**PR/0327/22**

## Record of Executive Business and Chief Executive's Order

**Reg. Reference:** SD21A/0161      **Application Date:** 21-Jun-2021  
**Submission Type:** Additional      **Registration Date:** 09-Feb-2022  
Information

**Location:** Lucan Shopping Centre, Newcastle Road, Co. Dublin

Figure 4: Alternative Pedestrian / Cycle Routes Considered

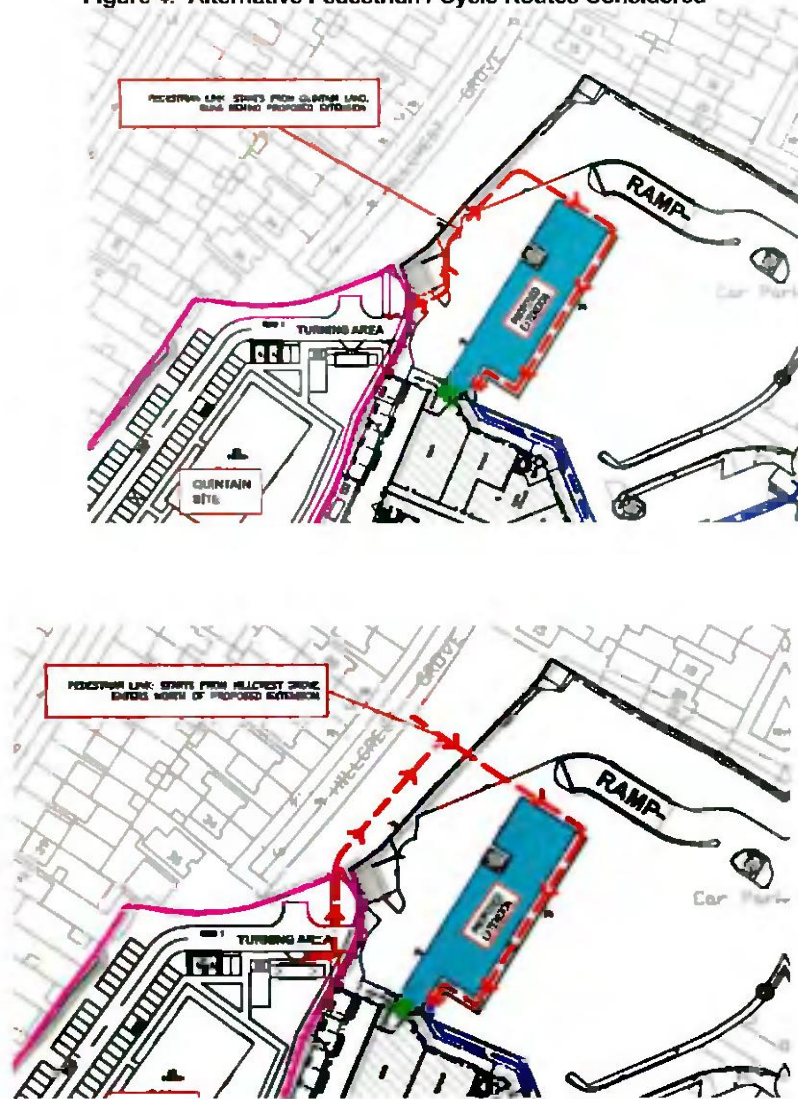
The Planning Authority consider that the design of the proposed pedestrian/cycle link into the Adamstown SDZ lands remains an issue of concern. The proposed route would be closed to all pedestrians to allow delivery vehicles to access or egress between the existing service yard and the new service yard of the proposed development. Furthermore, the Planning Authority would maintain serious concerns in relation to the proposed closing of the proposed pedestrian route outside of the opening hours of the shopping centre. While the submission of the applicant in this regard is noted, it is considered that the design in its current format would create a convoluted and uncertain route, which would be of substandard quality. In particular, the proposal in its current format would fail to comply with the South Dublin County Council Development Plan 2016-2022, particularly UC1 Objective 4, 5 and 7, all of which support the provision of high quality, usable and safe public realm and pedestrian routes and is therefore not considered to be acceptable.

The current proposal for the pedestrian / cycle link was ultimately chosen as it:

Figure 4.1 Extract from Swept Path Analysis

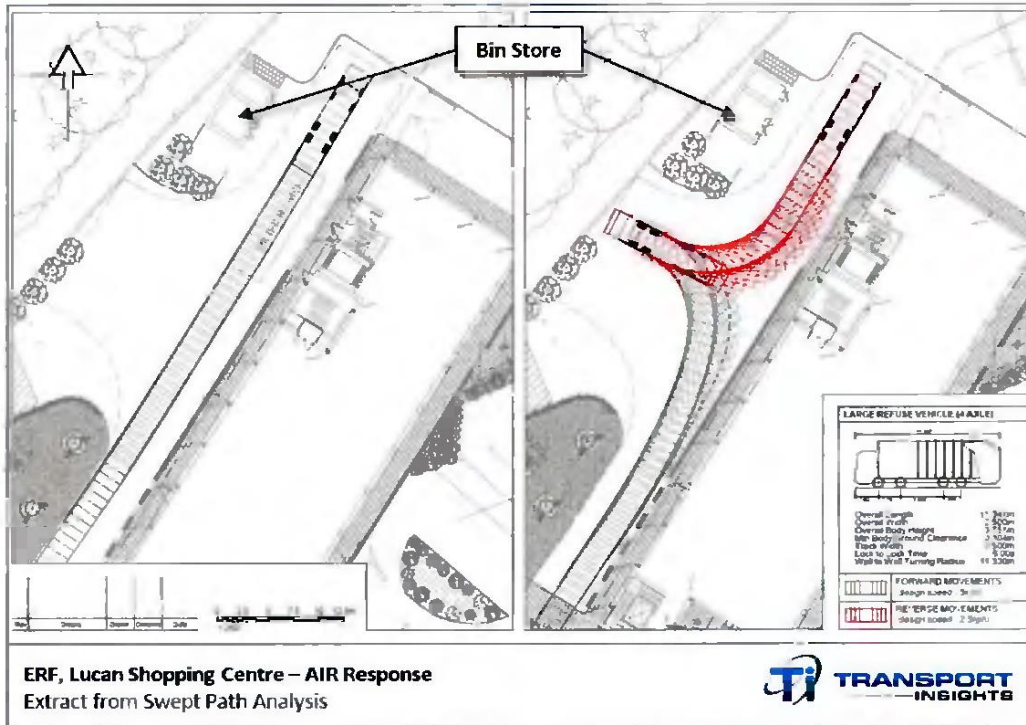
A swept path analysis has been undertaken to demonstrate the suitability of servicing arrangement in accommodating a large refuse vehicle to access, circulate within and egress the proposed servicing area. The following Figure 4.1 presents an extract of the swept path analysis drawing with a to-scale drawing included in Appendix E.
